NOTICE OF DECISION

MINOR HISTORIC DESIGN REVIEW CASE NO.: HIS21-17

SUMMARY: A proposal to repair and replace three(3) staircases on the exterior of the John & Edith Rand House (c1892).

**HISTORIC DESIGN REVIEW CASE NO. HIS21-17
DECISION**

STAIR #1 SOUTH ELEVATION VIEW
(FRONT VIEW)
SCALE: 1/2" = 1'-0"

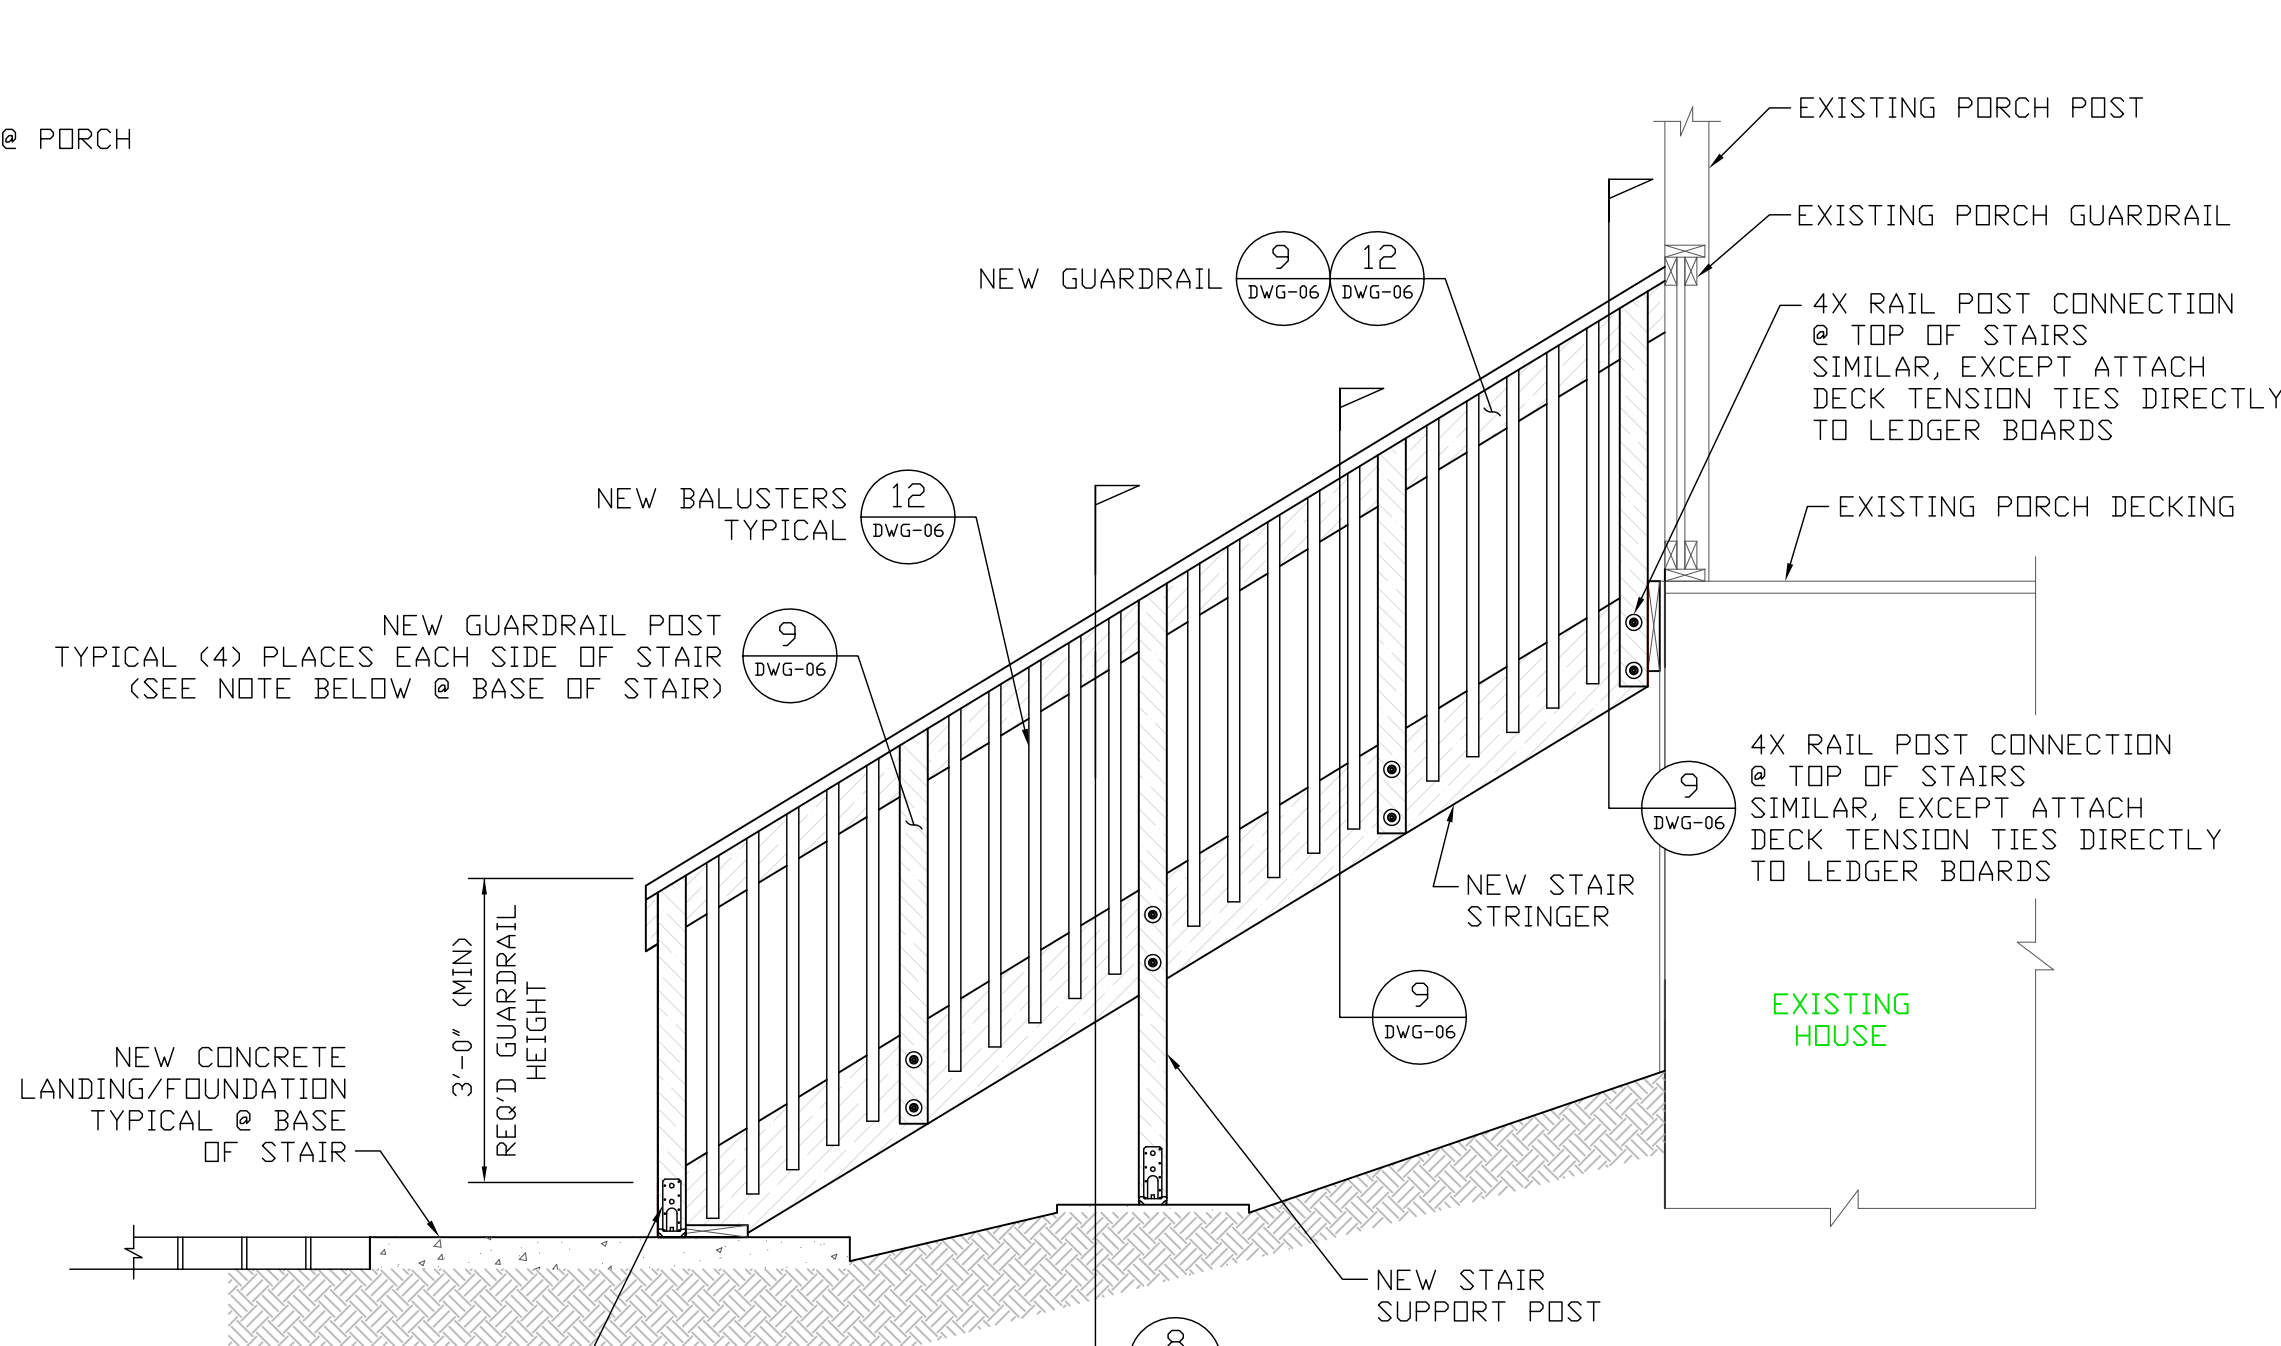
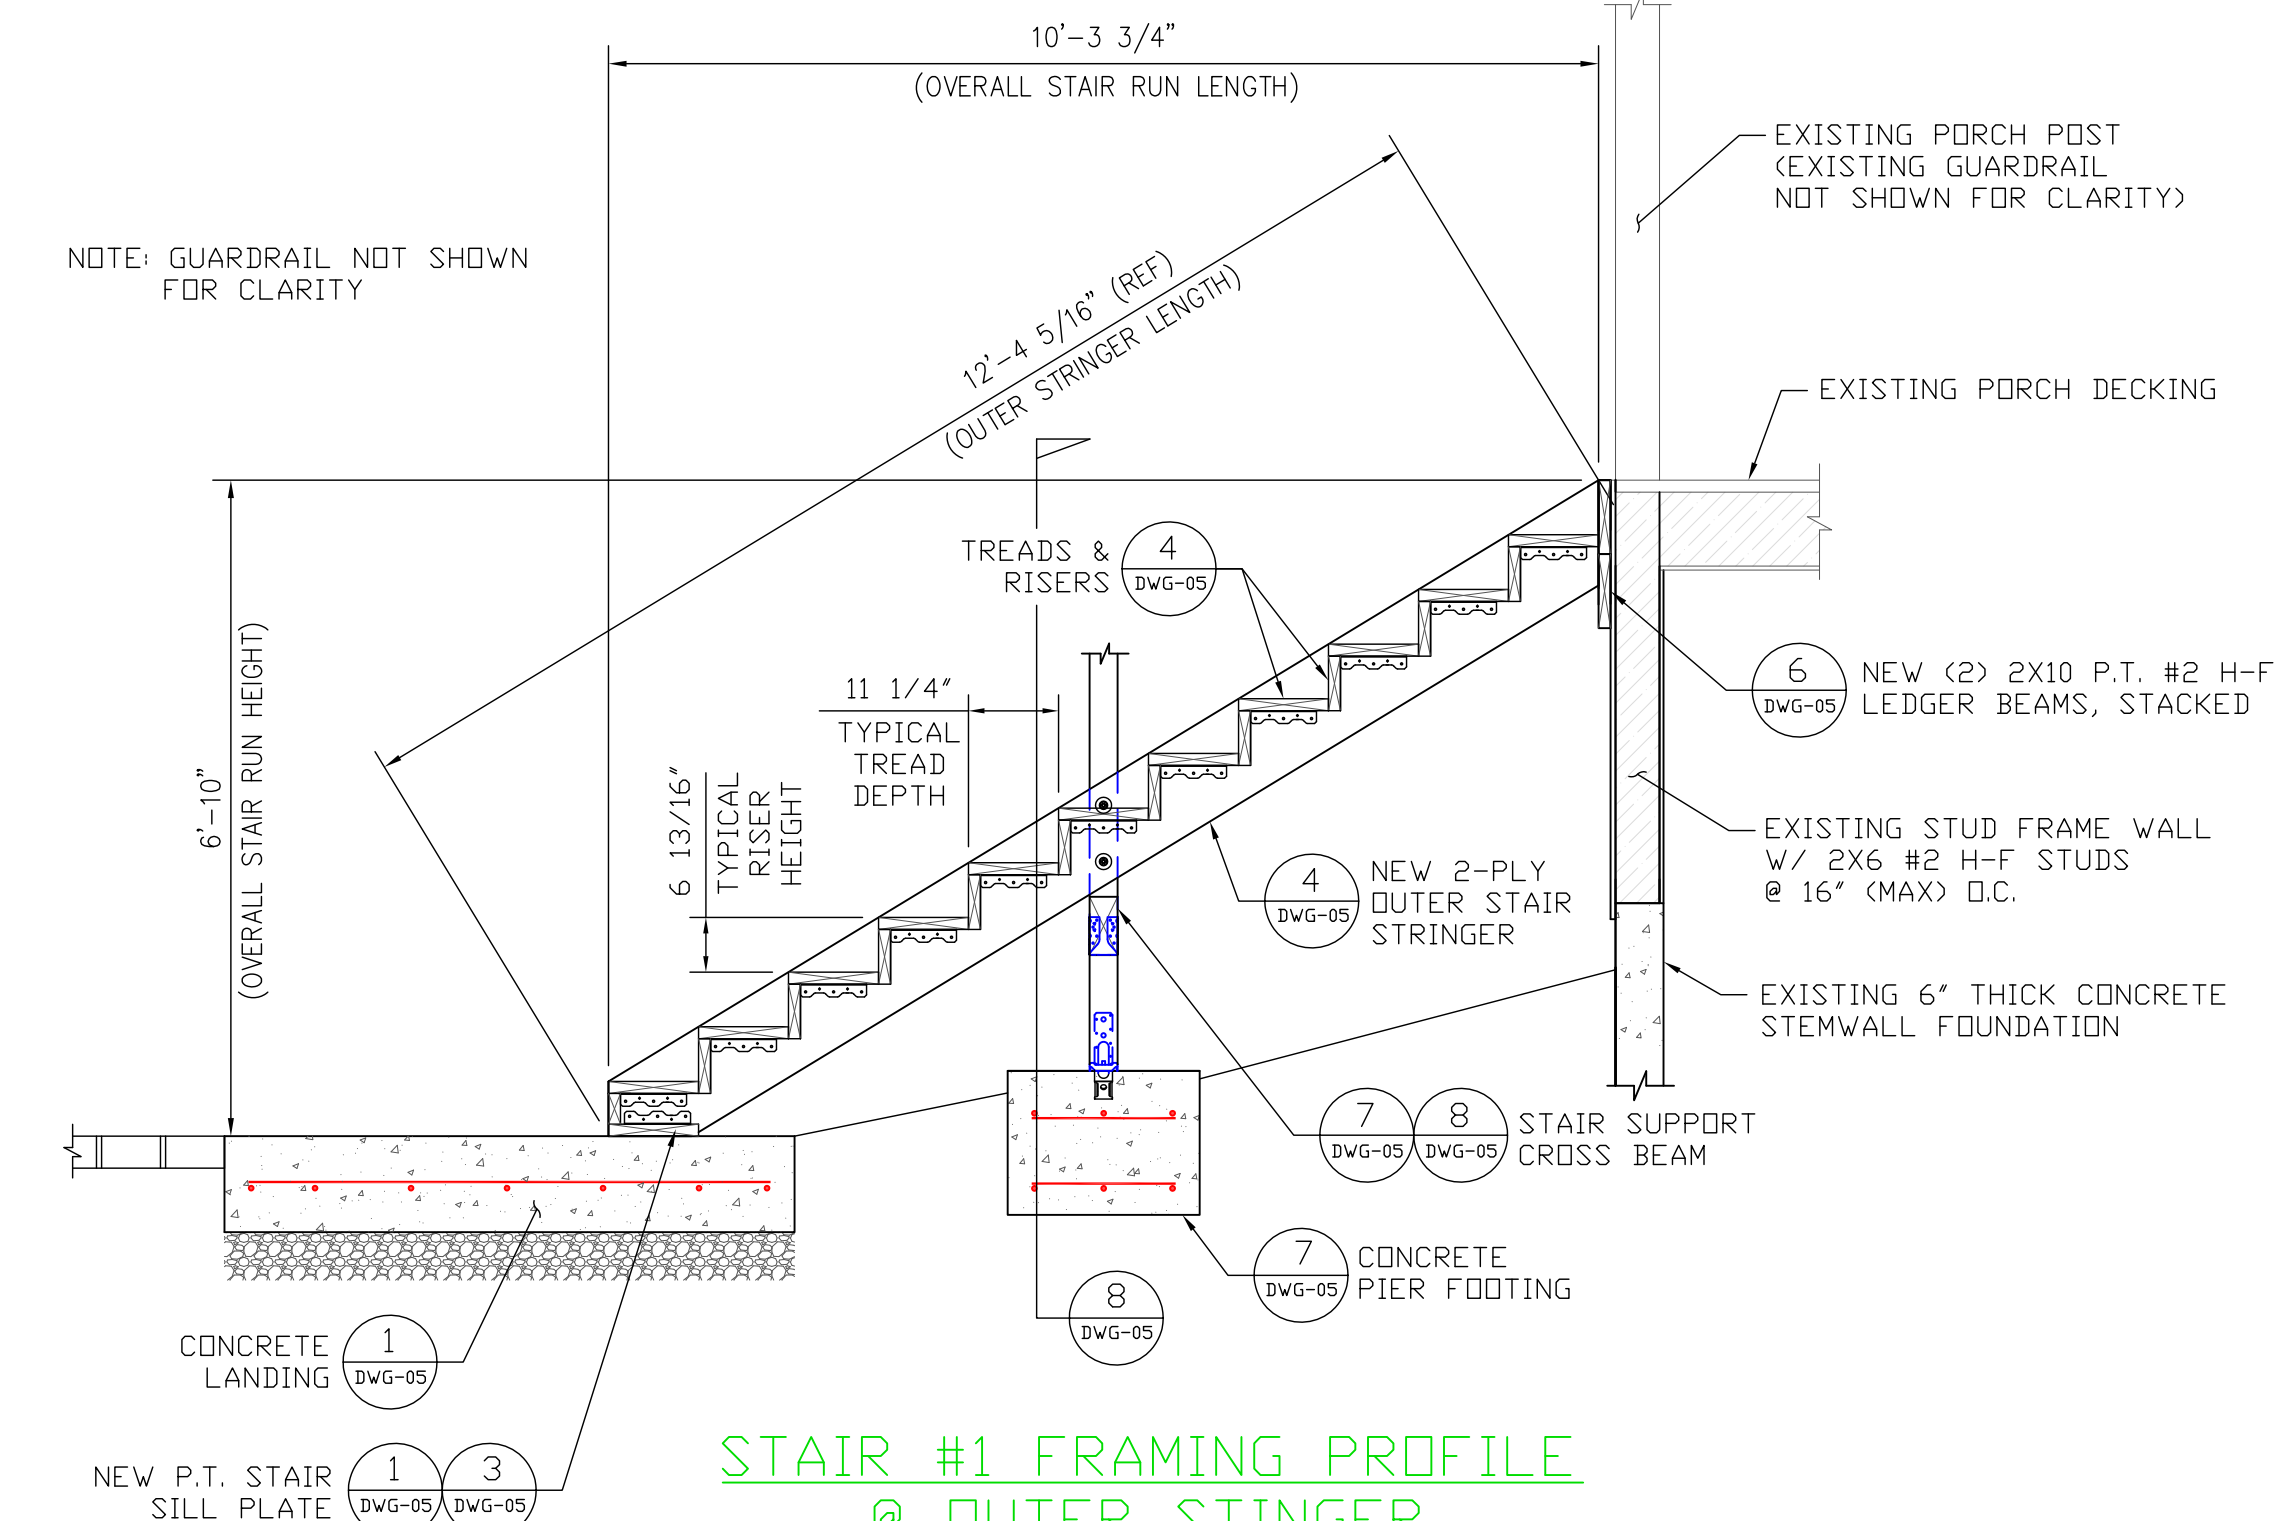
Condition 1: The applicant shall ensure that the posts at the base of the stairwell on the south side of the resource are replaced with turned posts that match the material of the original. Pressure treated wood shall not be utilized.

Condition 1: The applicant shall ensure that the posts at the base of the stairwell on the south side of the resource are replaced with turned posts that match the material of the original. Pressure treated wood shall not be utilized.
